STAFF REPORT
KETCHUM PLANNING AND ZONING COMMISSION
REGULAR MEETING OF JUNE 8, 2020

PROJECT: Bavarian Village Townhomes

FILE NUMBER: P20-030

TO: City of Ketchum
FROM: Sherri Newland, PE
DATE: June 1, 2020
RE: Preliminary Plat – Bavarian Village Townhomes – Subdivision of Lot 2

Exhibit B:
Preliminary Plat

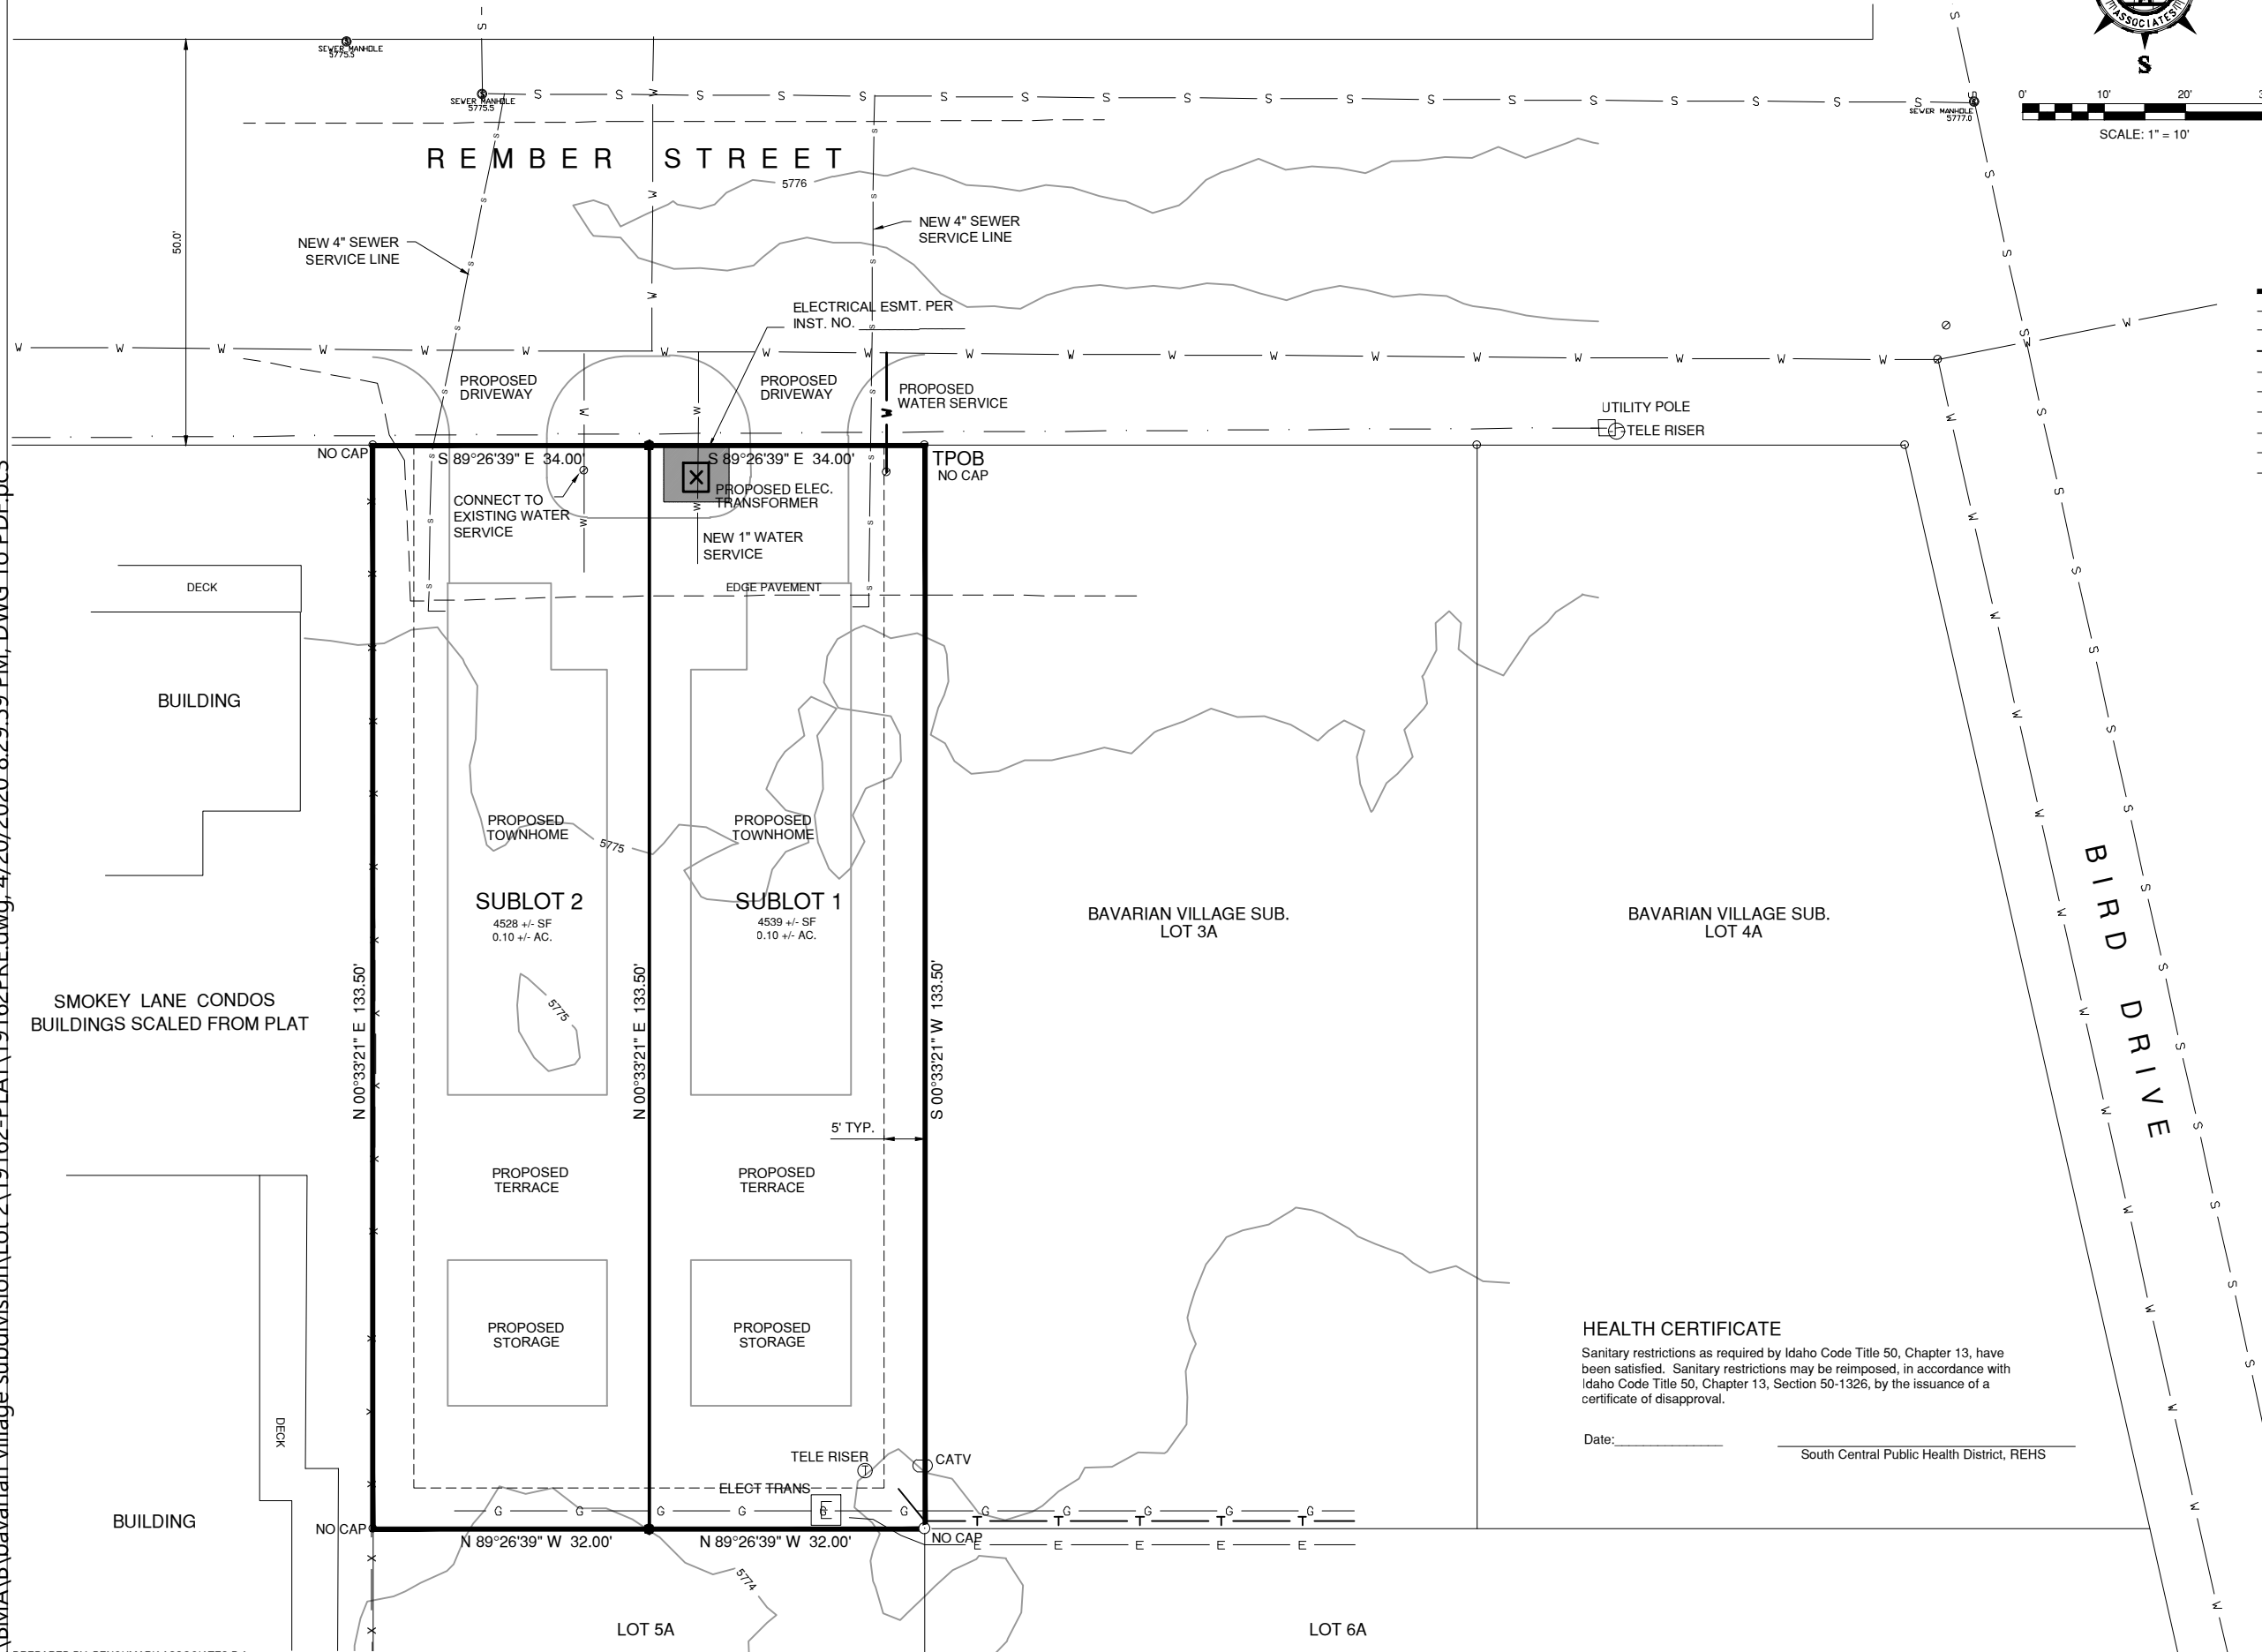
Per 12.04.30 Section G - Utility easements shall be provided along front lot lines, rear lot lines, side lot lines or other appropriate locations deep necessary. A 5' front lot line easement is needed.

The proposed water service and sewer service location has been modified from the approved building permit drawings and not accurately represented on the preliminary plat. The water and sewer line locations will need to be updated to reflect what was constructed in the field.

Basis of Bearing and a vicinity map need to be shown.
